**CORRESPONDENCE COVER SHEET  
WASTE PERMITS DIVISION  
TEXAS COMMISSION ON ENVIRONMENTAL QUALITY**

Date: October 20, 2022  
 Facility Name: Twin Oaks Power Station CCR Landfill  
 Permit or Registration No.: CCR112

**RE: Response to TCEQ Technical NOD 2 Correspondence Dated September 22, 2022  
Twin Oaks Power Station Coal Combustion Residuals Landfill  
Major Oak Power, LLC  
Bremond (Robertson County), Texas  
CCR Registration No. CCR112  
TCEQ SWR No. 37677; EPA ID No. TXD987997988  
Tracking No. 27247279; RN100226570/CN604670034**

● Monitor Well  
 -> Approx. Groundwater Flow Direction  
 — Groundwater Contour  
 □ Pond  
 — 5-ft Ground Surface Contour  
 □ Property Boundary  
 — Groundwater Elevation  
 385 (Elevation Feet, MSL)

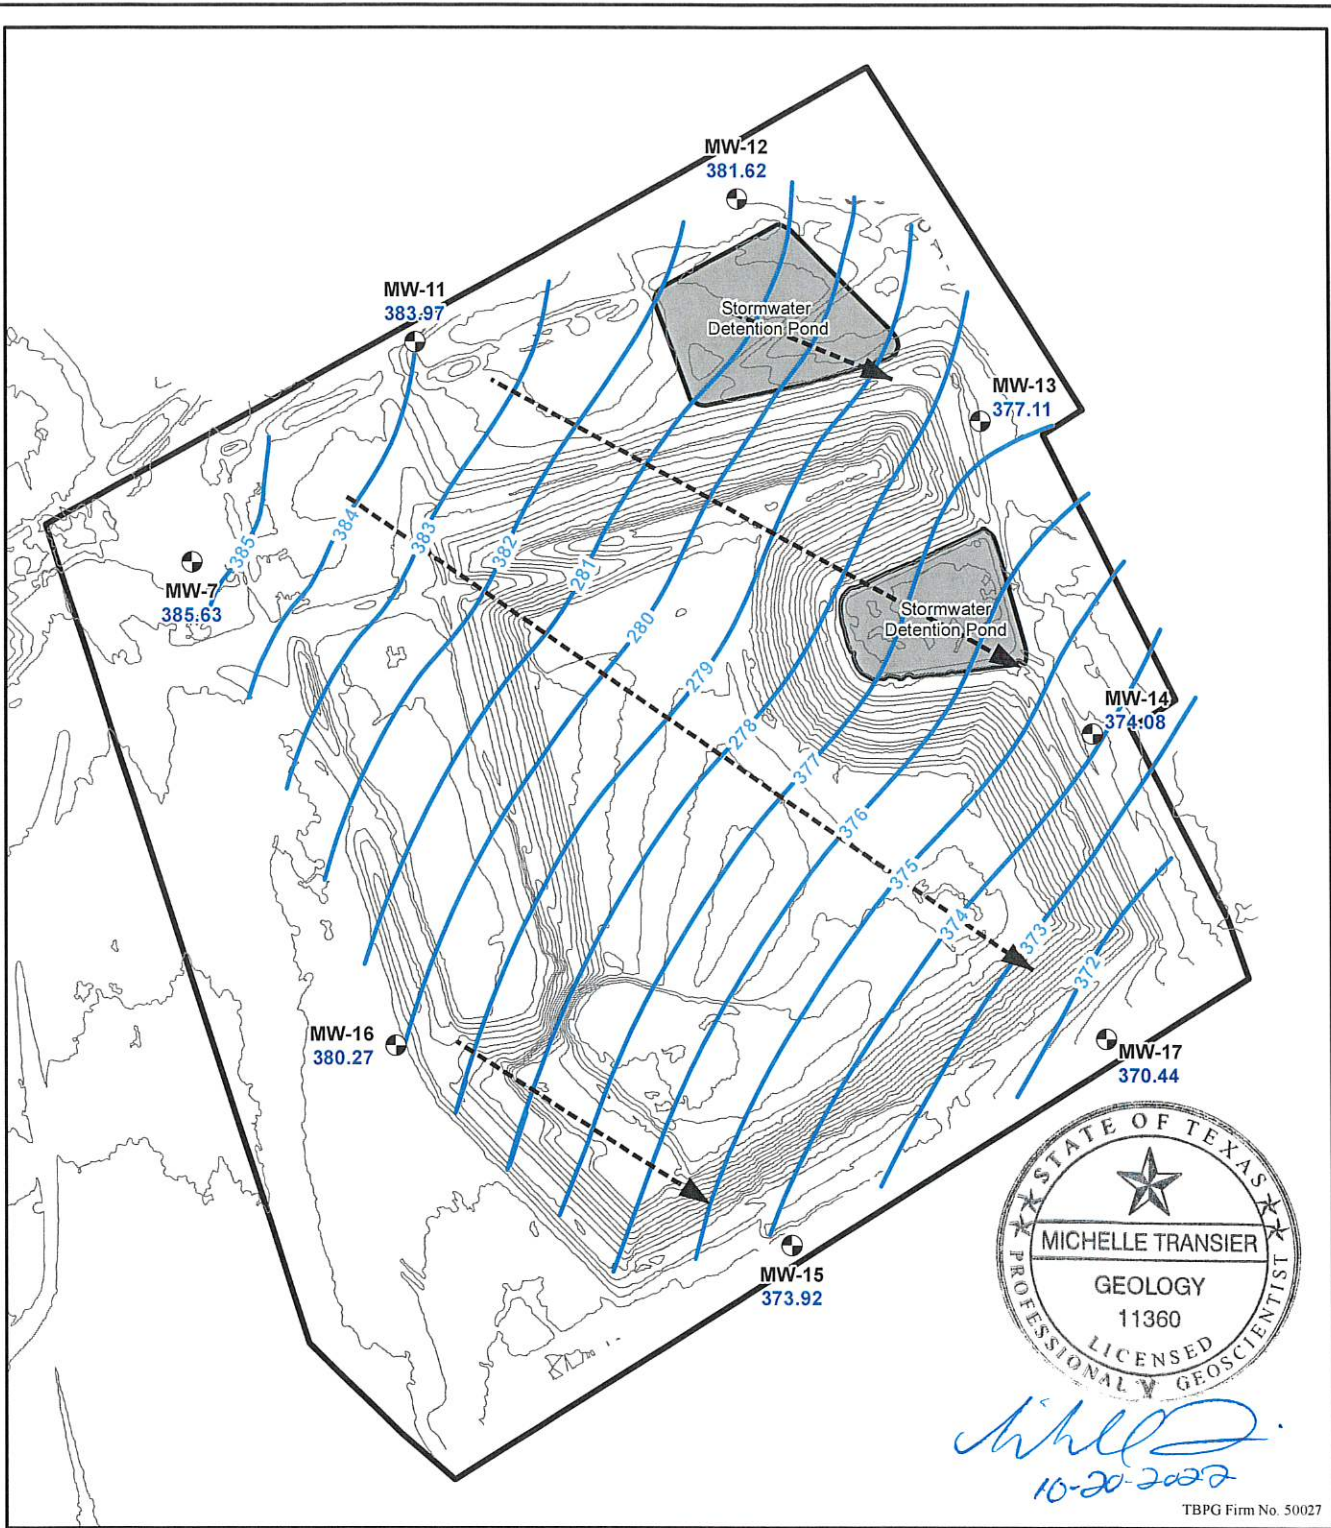
*Seal all of the groundwater contour maps and include the Firm Number.*

All groundwater contour maps have been signed and sealed by a licensed professional geoscientist in the State of Texas. The signed/sealed maps are attached herein.
